Town of Franklin

Planning Board

June 8, 2020

- 7:00 PM Commencement/General Business
- 7:05 PM <u>PUBLIC HEARING</u> Continued 176-210 Grove Street Site Plan

SITE PLAN LAYOUT

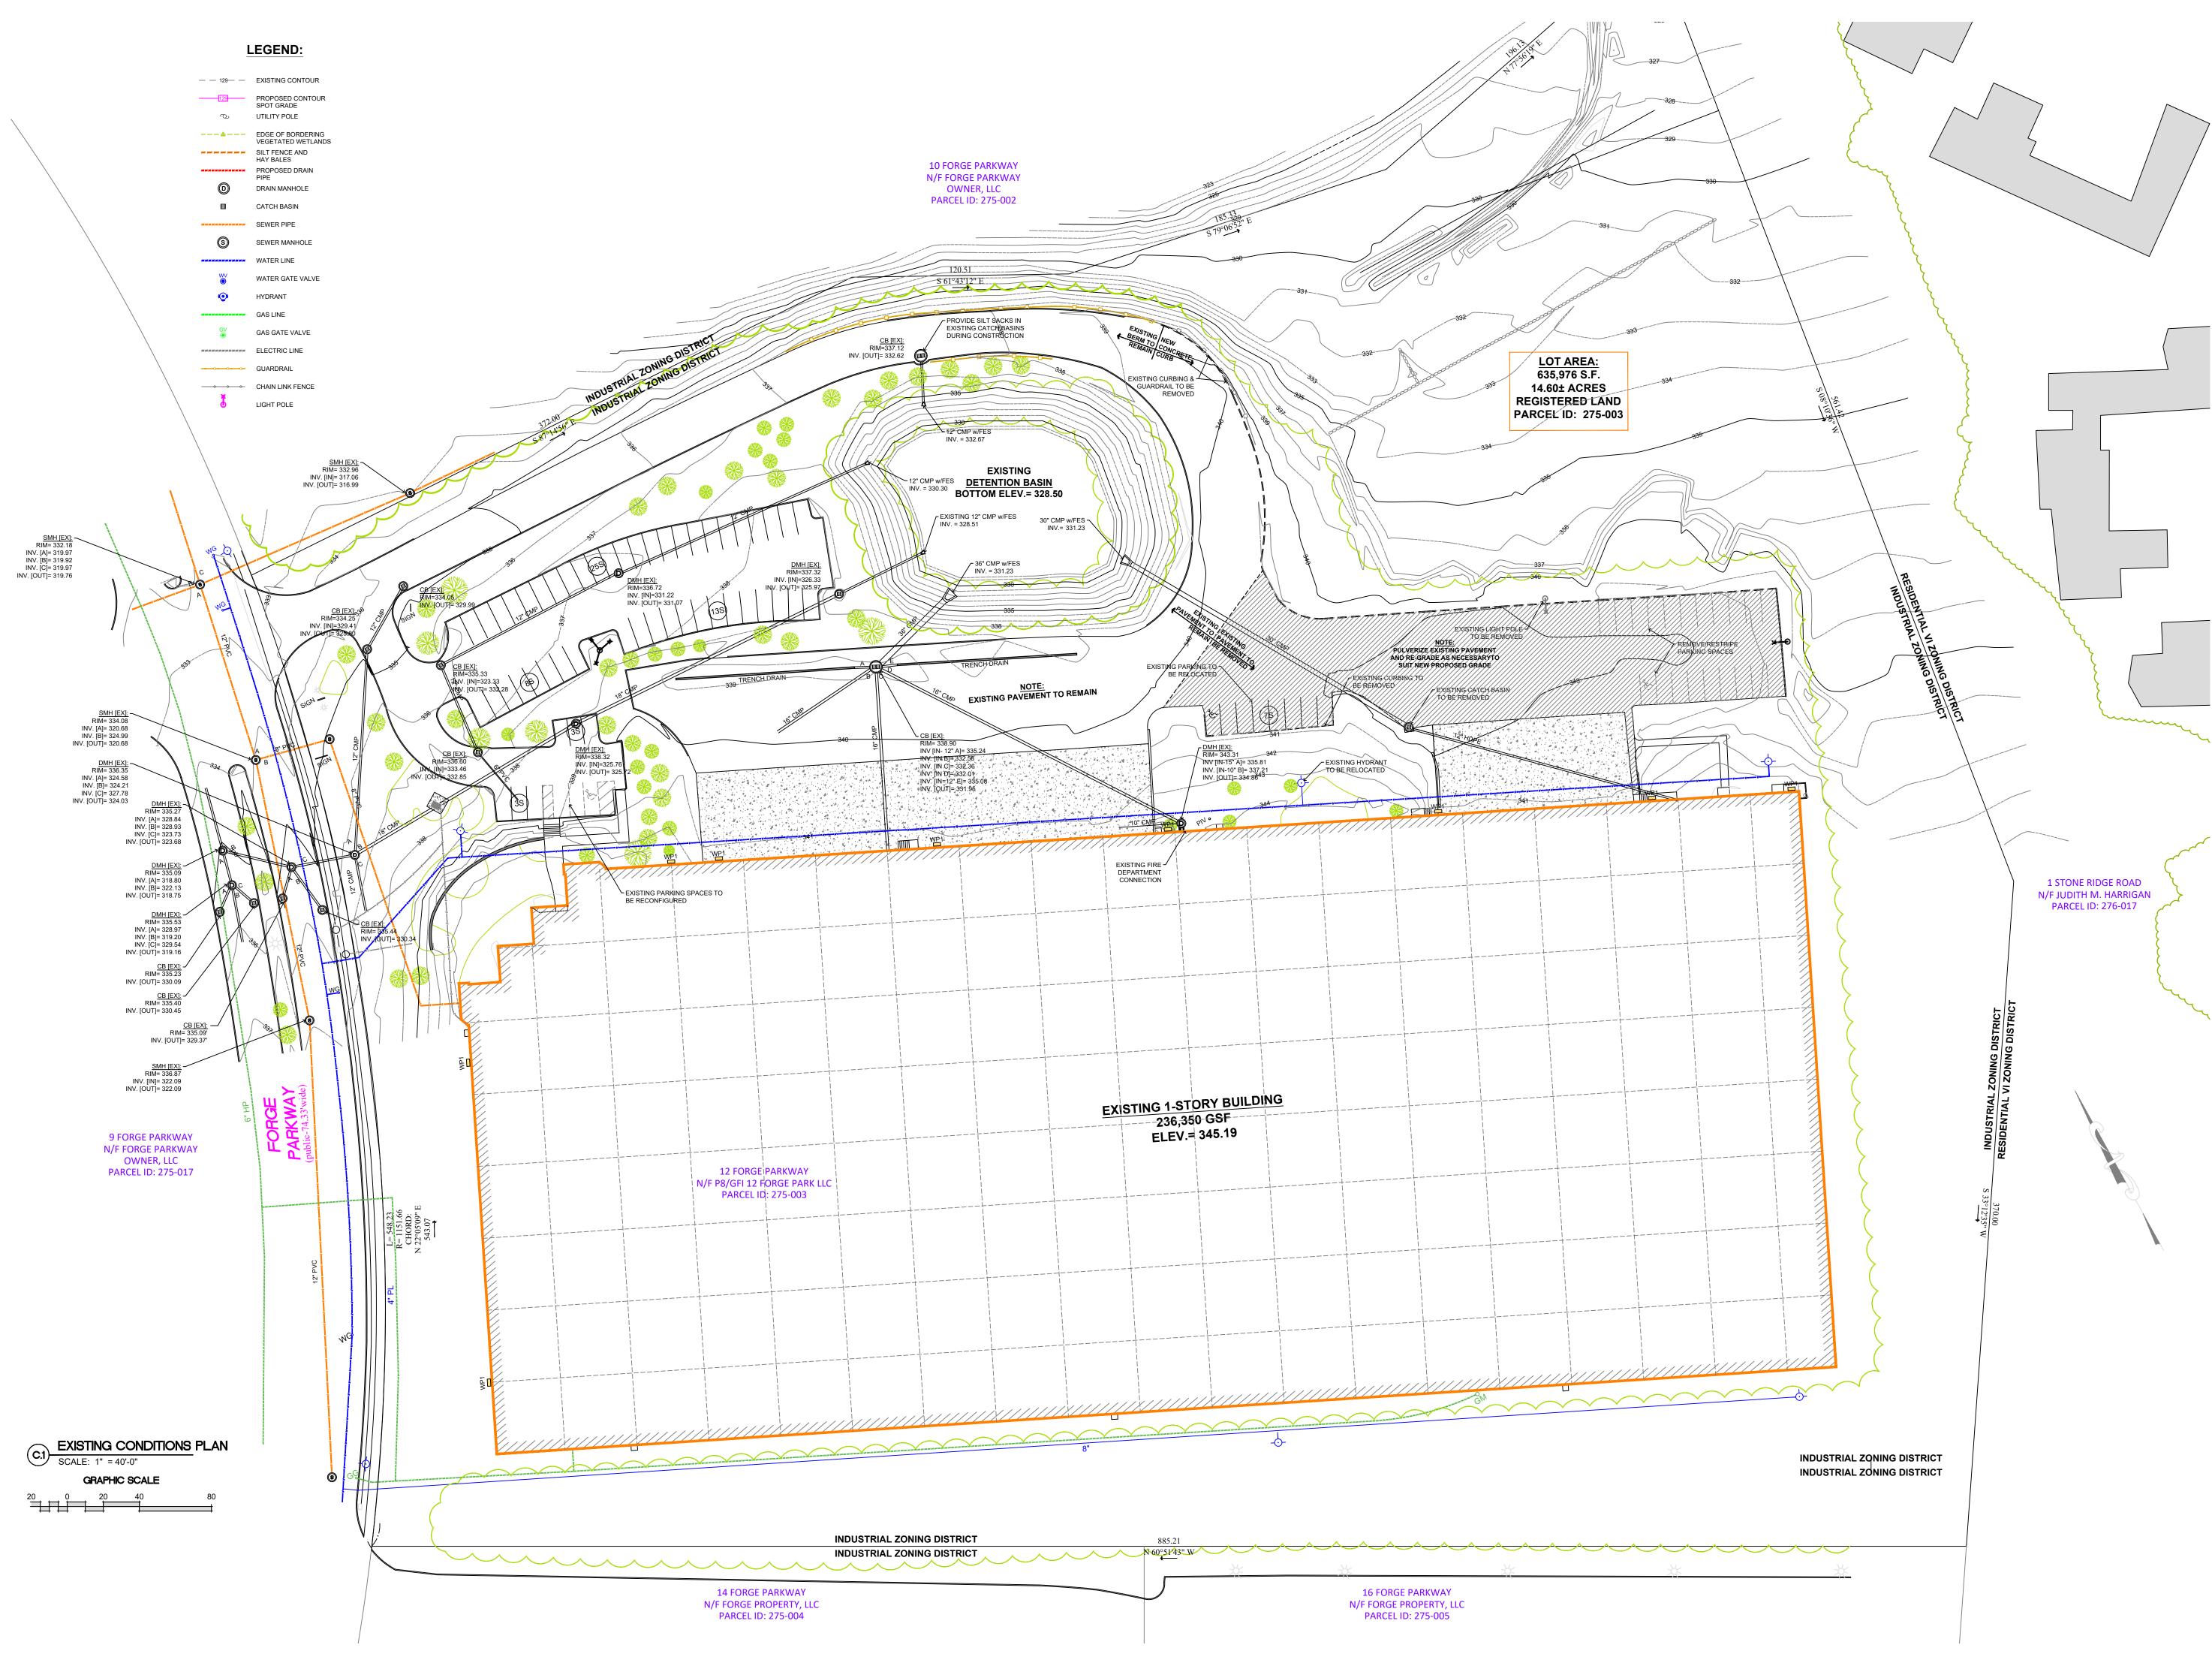
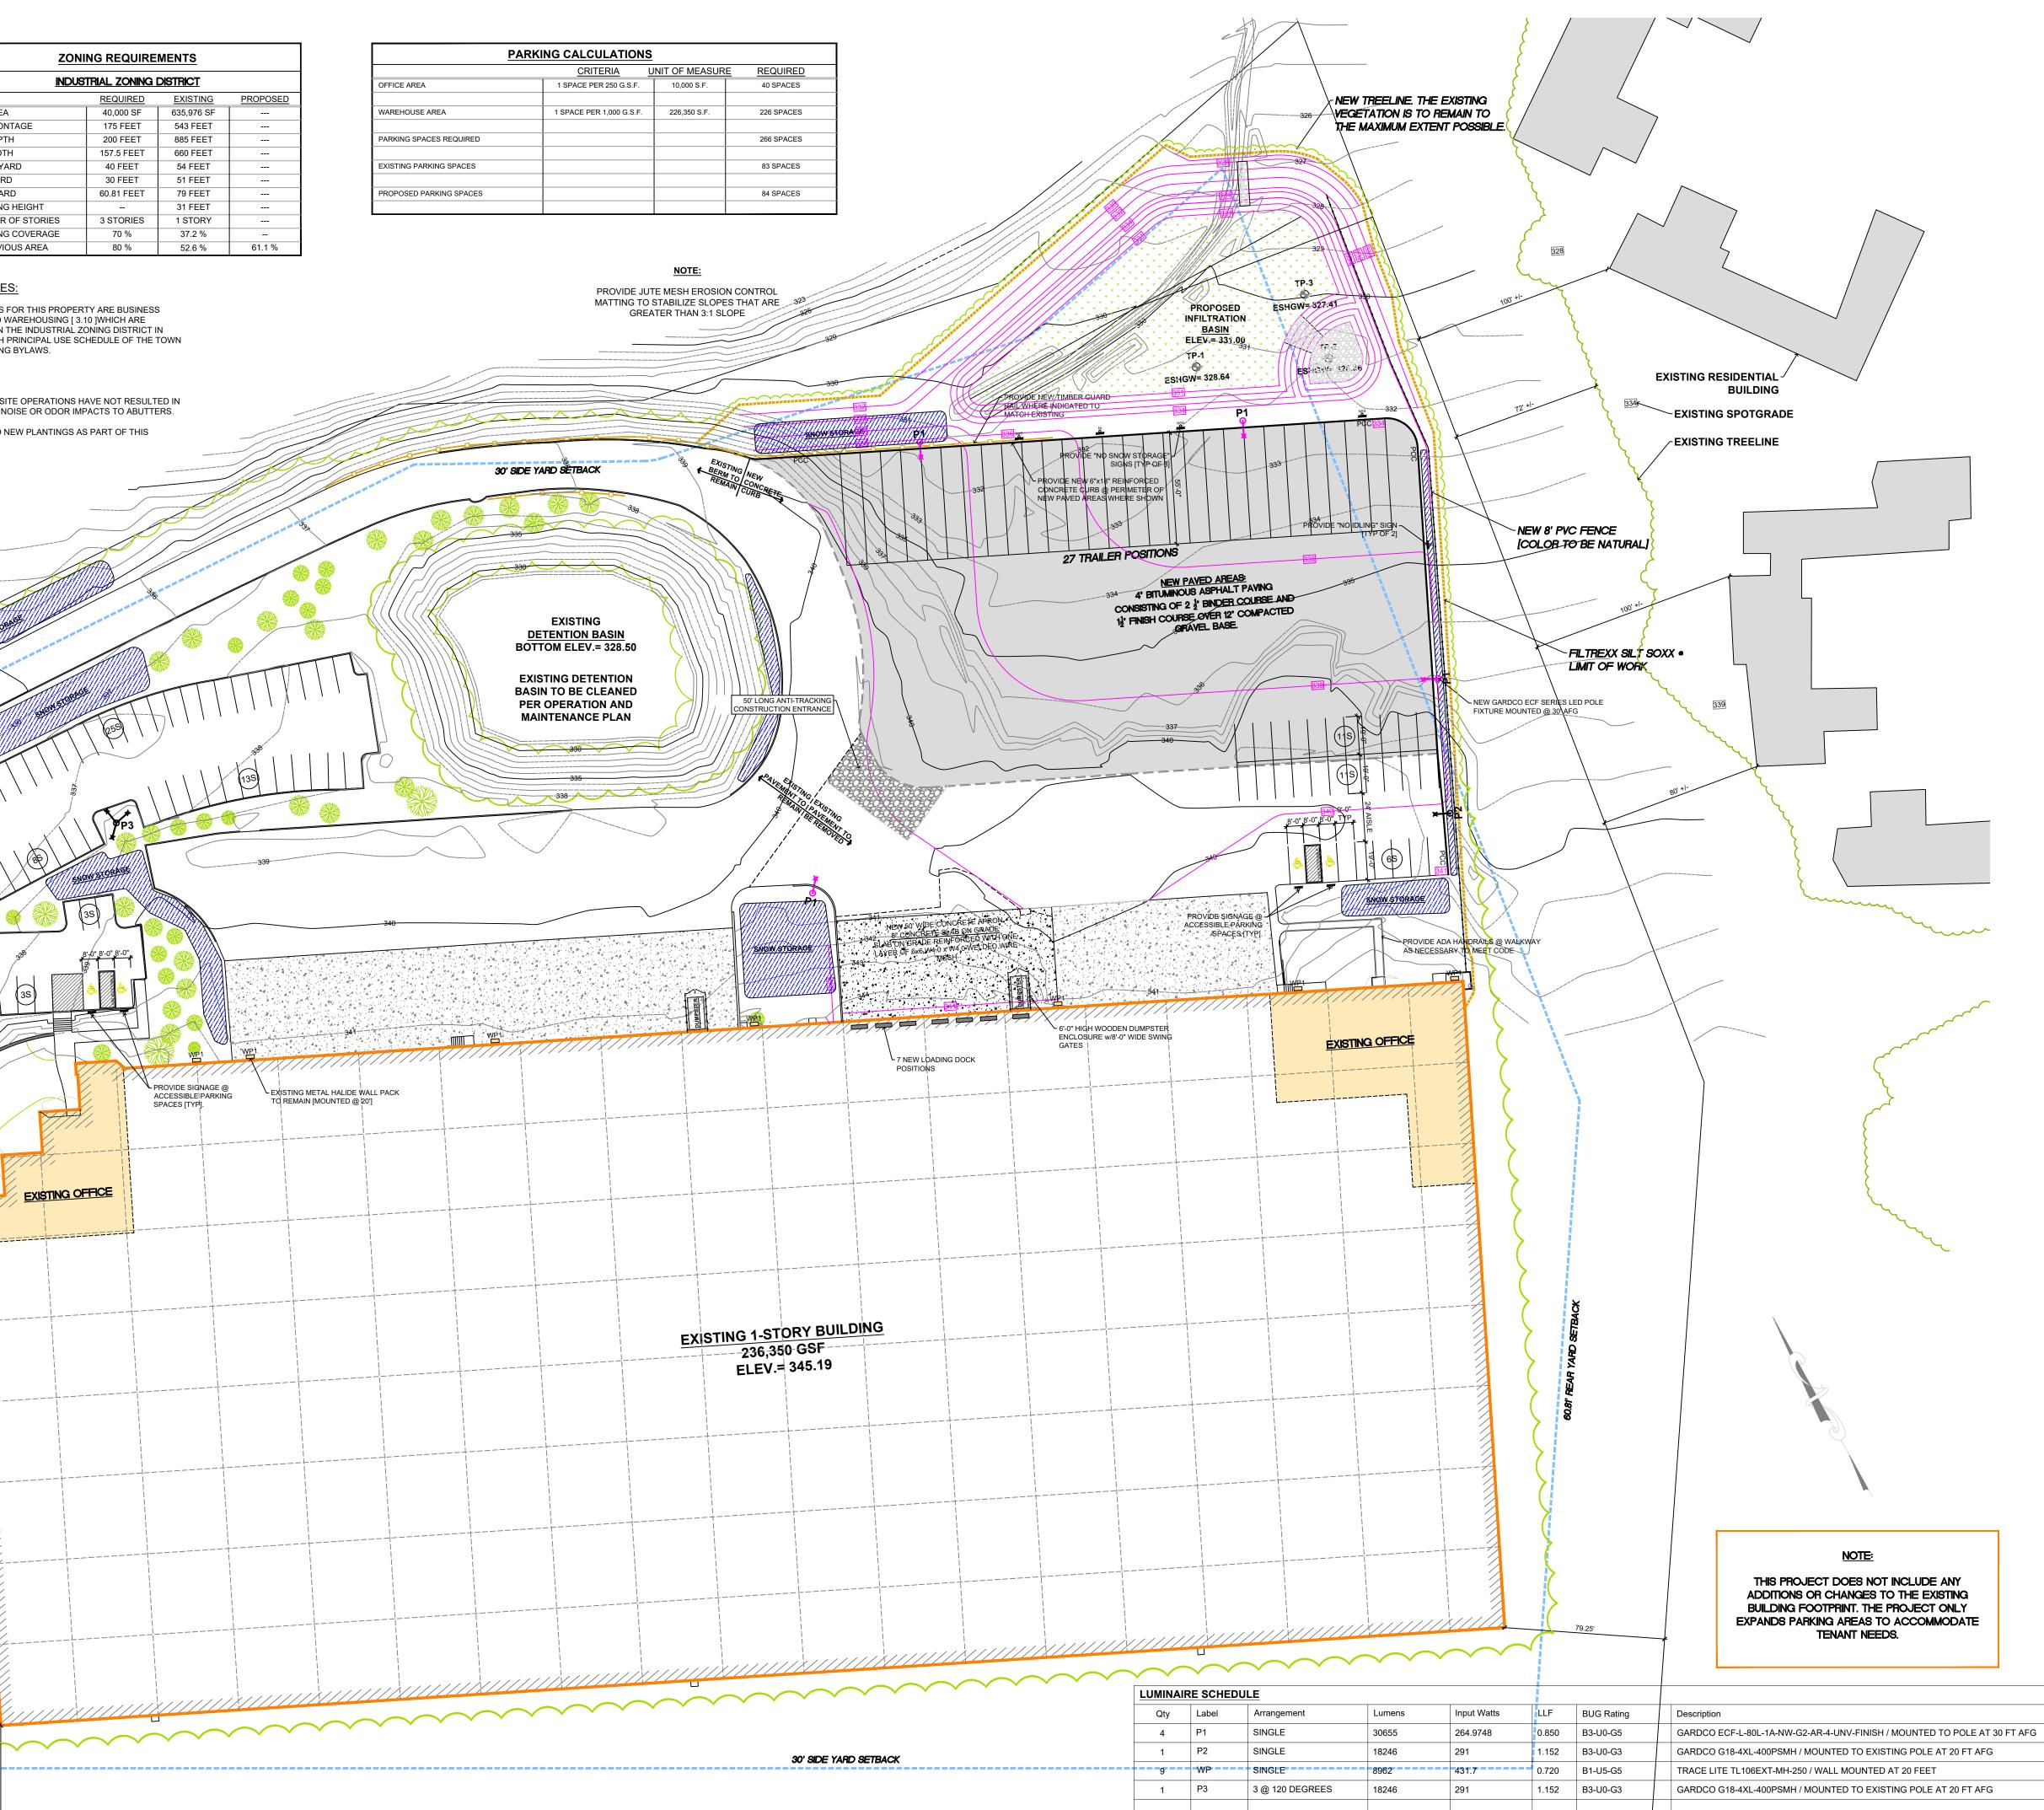
show parking availabilit 12. Prior to Endorsement, the following changes are to be made to the plans

. Signage should be added to the plans to show "No idling:" where the truck parking is located

The curbing shall be reinforced concrete and should be on the plans and in the details
 A natural color fence shall be installed along the property, as shown on the plans The dumpster shall be on a concrete pad with a fence e
